Official Transcript of Proceedings ACRST-3304

Title: Advisory Committee on Reactor Safeguards  
519th Meeting

Date: Thursday, February 10, 2005

POWER UPRATE FOR WATERFORD NUCLEAR PLANT . . . . . 6

## Boric Acid Precipitation BACCHUS Test Results

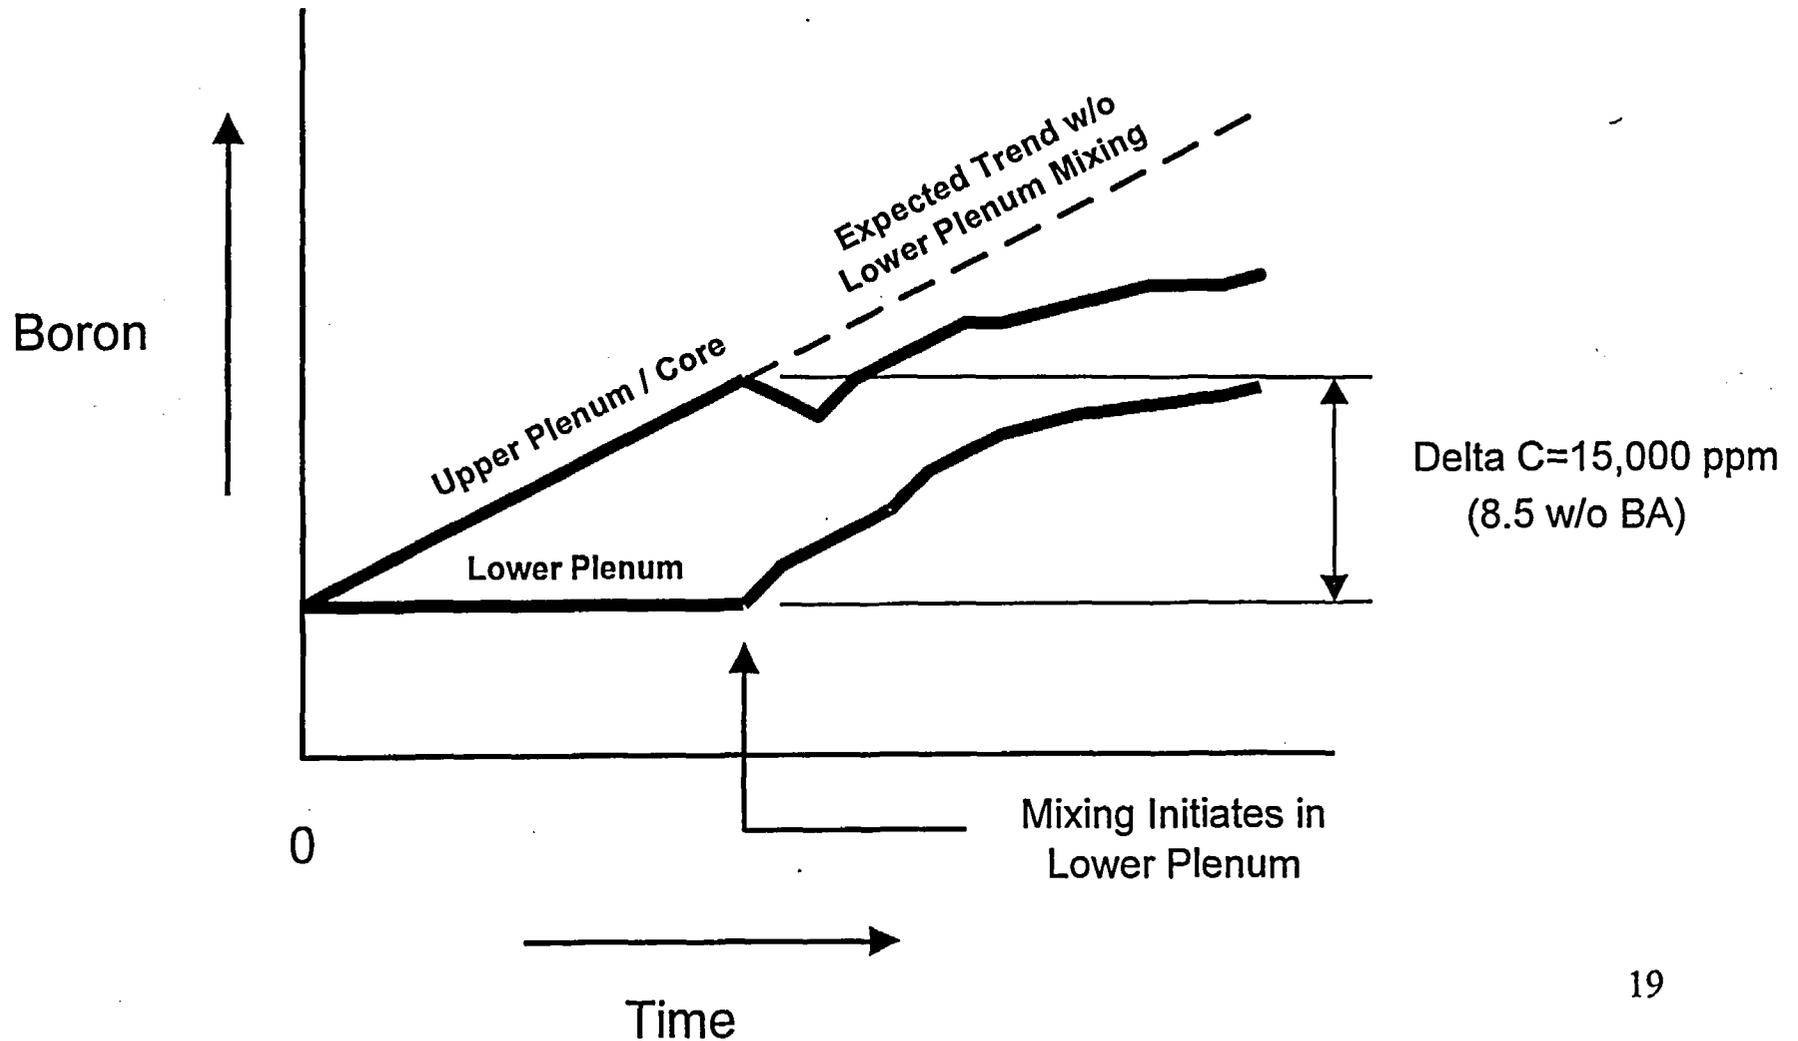
10 MR. ROSEN: Could I hold you here? It's  
11 instructive to me to look at your left diagram in  
12 relation to the discussion we had before about what  
13 you include are the upper plenum. In the upper plenum  
14 you said it's included up to the top of the hot leg,  
15 if I'm correct; which means it's included basically.  
16 Is that correct?

18 DR. DENNING: And what do you think that  
19 cell size looks like? I mean, if it falls — it's a  
20 critical question, I think, as to what do you really  
21 picture in your mind as to what that cell size looks  
22 like over which the circulation occurs, because if  
23 it's going down one area, it's going up some other  
24 area. Right?

7 DR. KRESS: It actually might help if you  
8 had the three-dimensionals, but I think you haven't  
9 shown that. You're just setting that. I think I  
10 would like to see some analysis somehow. I think in  
11 a relatively simple analysis you can show that.

15 DR. WALLIS: Are you going to actually  
16 show us those numbers?

17 MR. BROWN: No, I'm not going to show you  
18 MHI's proprietary data. That's why I've drawn this  
19 nice little cartoon today. However, it is in the  
20 BACCHUS report, which the Staff has, if you're  
21 interested in looking at the actual data.

# Boron Concentration vs. Time

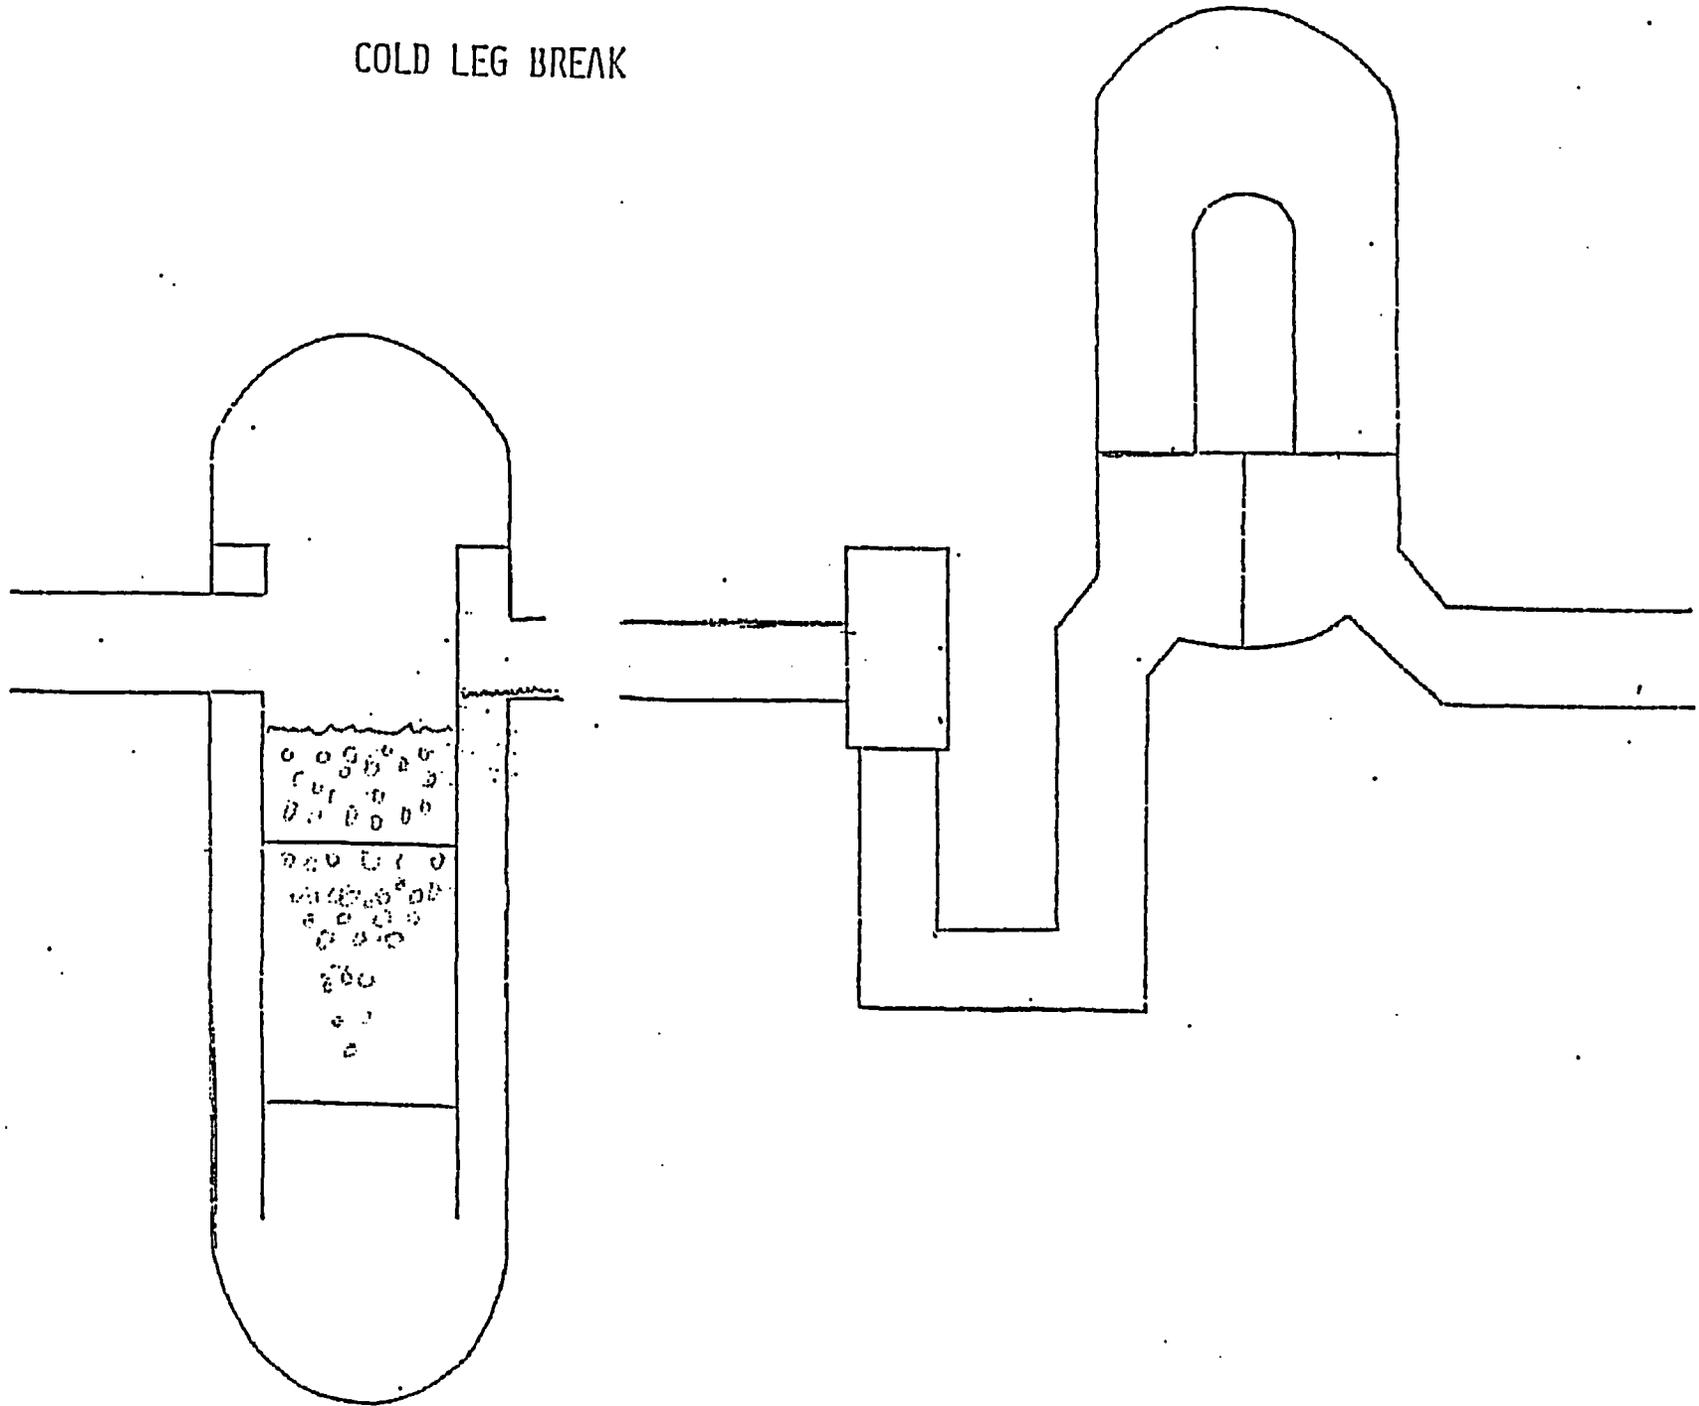
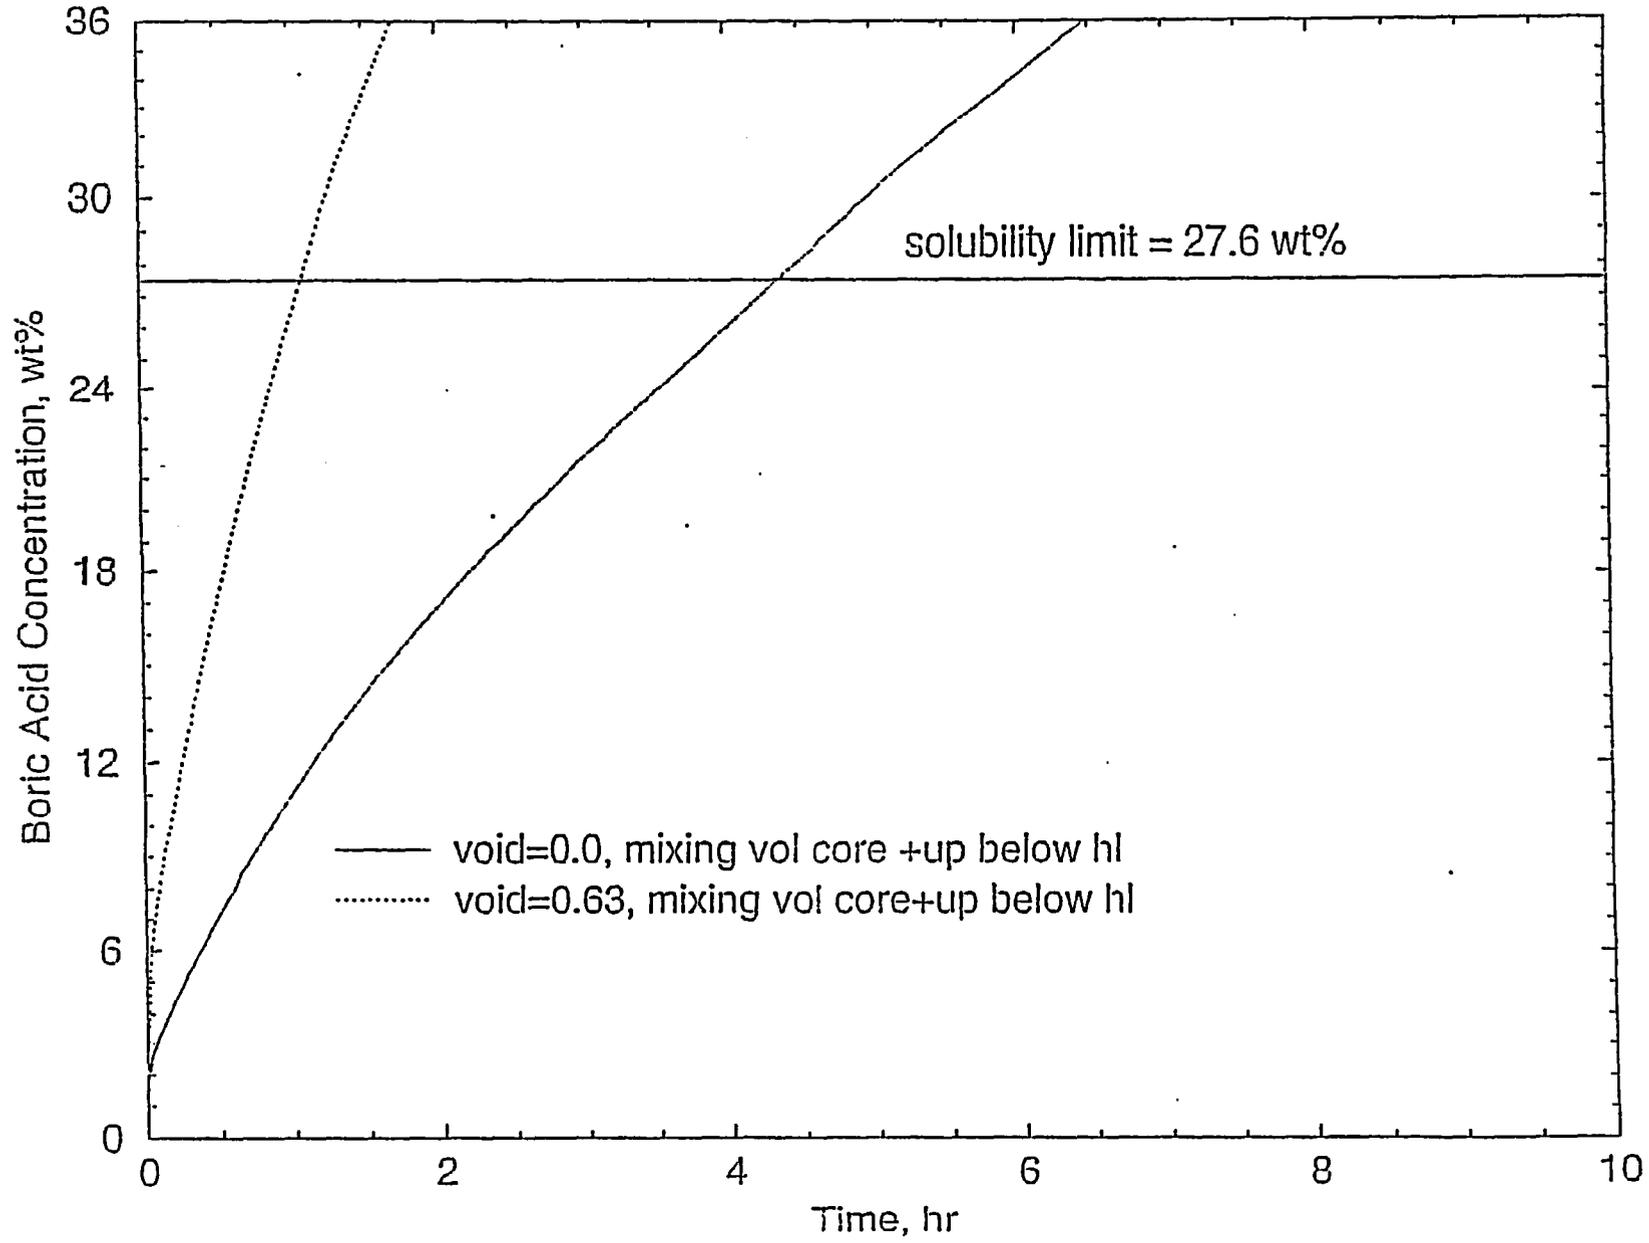
8 Let me show you what I just said, what it  
9 looks like. This is the licensing calculation with  
10 zero liquid fraction. And, basically, what I did is  
11 I used their licensing —

20 MR. WARD: So now when you put the correct  
21 void fraction in, it shifts us back to here. And this  
22 is precipitating in an hour. Now this is a licensing  
23 calculation.

5 MR. WARD: I don't think they need to take  
6 credit for that in the long run, but let's — you may  
7 not even ask that question when we see where we're  
8 going here. If now I throw in the hot leg in the  
9 mixing volume, I've got more volume to mix. The two-  
10 phase level is now near the top of the hot leg. It's  
11 going to delay the precipitation time, and if we look  
12 at three-hours, I mean, we're down around 24 percent.  
13 And if we're using a 14.7 limit, a 20 psi limit, or  
14 with the TSP, the limit is up here.

8 MR. WARD: So these calculations show that  
9 you're at half the limit at the switch time, and they  
10 even show that you could — you don't need the higher  
11 containment pressure, and you could even almost go as  
12 far as to say if you look at those curves without  
13 lower plenum mixing, but with the hot legs, you're  
14 still beyond four hours, so it tells me there's some  
15 margin here. It's comforting.
